**Addendum No. 1 for Invitation for Bids
LCS Dunbar Middle School Window Replacement
2017-006**

ADDENDUM #1

Name of Project	Lynchburg City Schools Dunbar Middle School for Innovation Window Replacement
Location	Lynchburg, VA
Project No.	3531
Date	September 22, 2016

1 EAST ELEVATION - NEW - REVISED
 A1 SCALE: 1/8" = 1'-0"

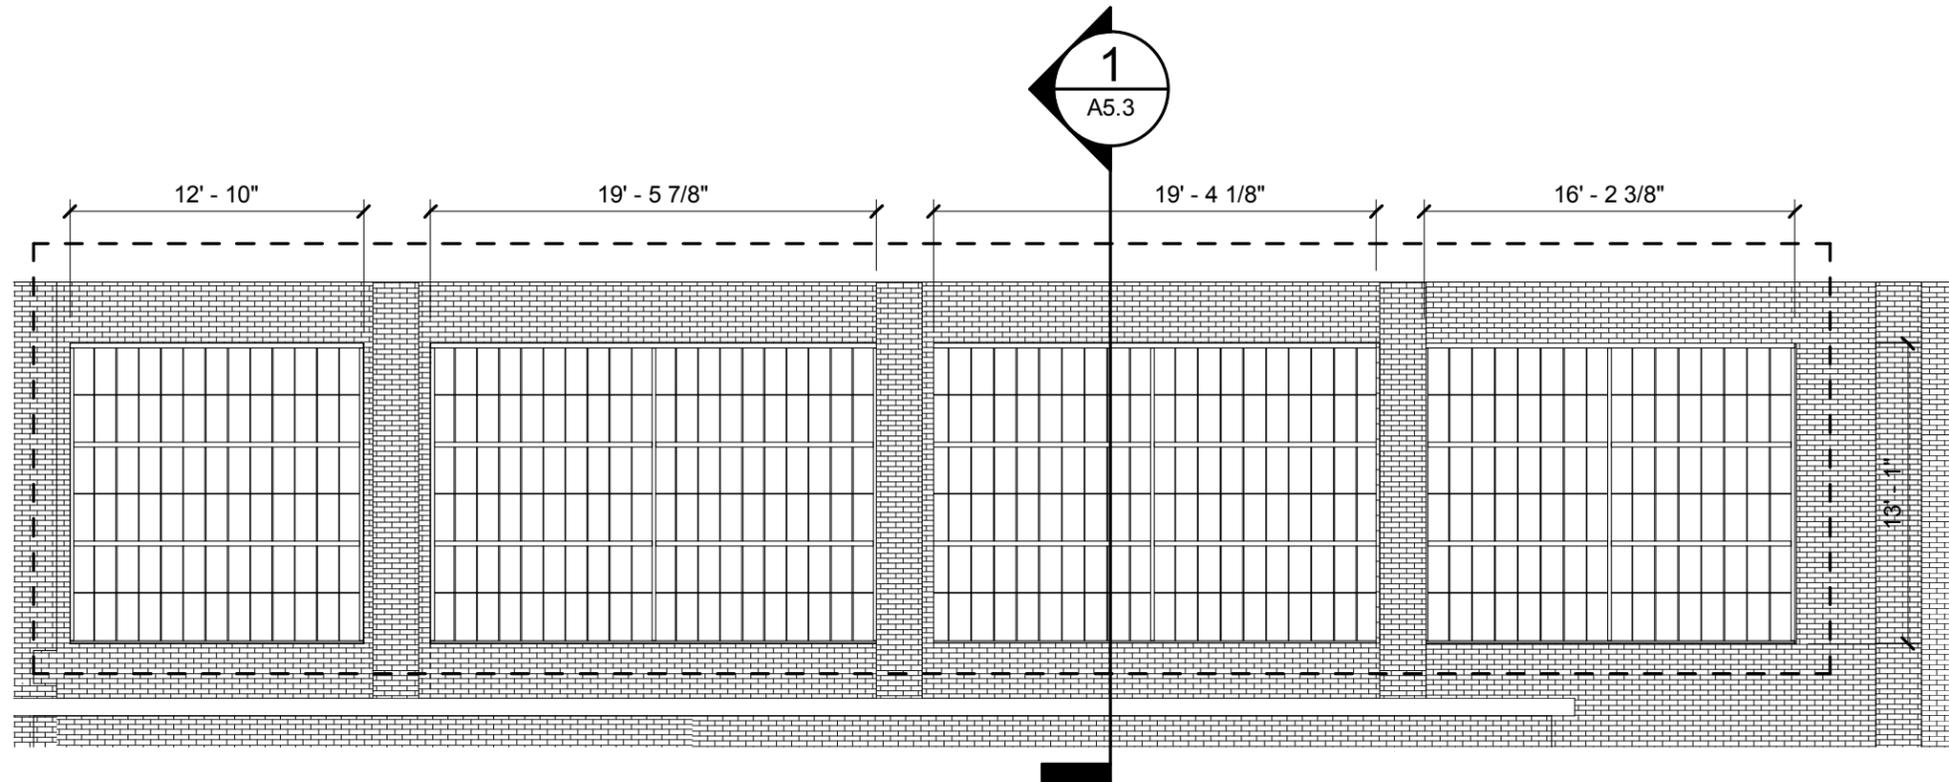
Sheet A4.2- North and East Elevations:

Please refer to attached Sketch A1 for dimensions shown for Kalwall system. All dimensions are to be field verified prior to fabrication of the Kalwall system.
